# CPPAL AFAP Validation

## As Far As Practicable (AFAP) Validation Assessment

Powercor Australia Ltd

<b>Project name</b>		Powercor AFAP Validation and Assessment Scope Review					
<b>Document title</b>		CPPAL AFAP Validation   As Far As Practicable (AFAP) Validation Assessment					
<b>Project number</b>		12620988					
<b>File name</b>		12620988-GHD-00-00-RPT-RM-00001-S4-P03-Powercor AFAP Validation Report.docx					
Status Code	Revision	Author	Reviewer		Approved for issue		
			Name	Signature	Name	Signature	Date
S3	A	R.Deo K.Pathak	B. Clarke		M. Erskine		18/03/24
S4	0	R.Deo K.Pathak	B. Clarke		B. Clarke		20/05/24
S4	1	R.Deo	M.Erskine		M.Erskine		05/12/24

**Bushfire Risk Tool (BRT) figures used  
within CPPAL-RP-0003**

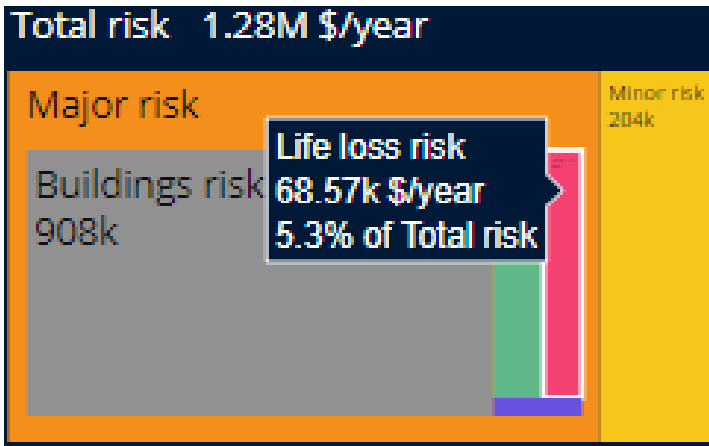
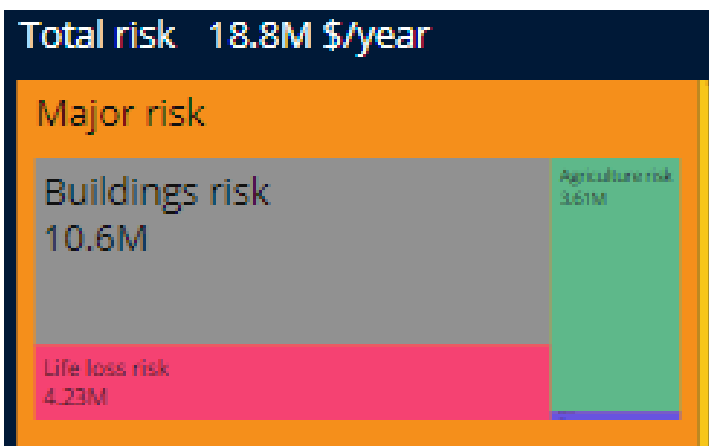
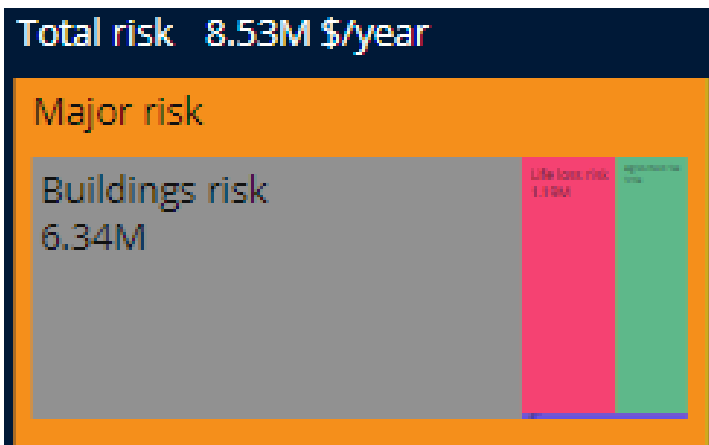
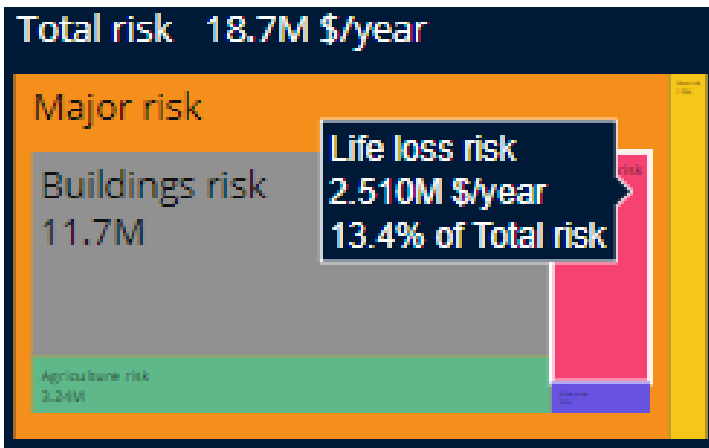
9. ■ Following the above, the DF per fire area refers to a life loss risk fraction figure obtained from the BRT as per advice from CPPAL. A reference to the source material for the life loss risk fraction \$ per annum. value is not currently provided. It is recommended that these values are included in the BRTP for a record of the inputs. A record of the figures will also serve as a reminder for future updates to the calculations if the results of the BRT modelling change.

15	9	Following the above, the DF per fire area refers to a life loss risk fraction figure obtained from the BRT as per advice from CPPAL. A reference to the source material for the life loss risk fraction \$ per annum. value is not currently provided. It is recommended that these values are included in the BRTP for a record of the inputs. A record of the figures will also serve as a reminder for future updates to the calculations if the results of the BRT modelling change.	Non-critical discrepancies and gaps
4	2	In the BRTP reference is made to CPPAL’s BRT that enables the computation of the likelihood of groundfire ignitions for a range of Fire Danger Indexes (FDIs), i.e. consequences, subsequently deriving the present risk exposure. In the revision sighted, there are no references provided to further contextualise this process. GHD are aware that this is a complex model that is beyond the scope of the AFAP documentation reviewed. Despite this, it is recommended that reference is made to an overarching, internal document to provide CPPAL readers with an opportunity to review details associated with the bushfire risk modelling.	Opportunity
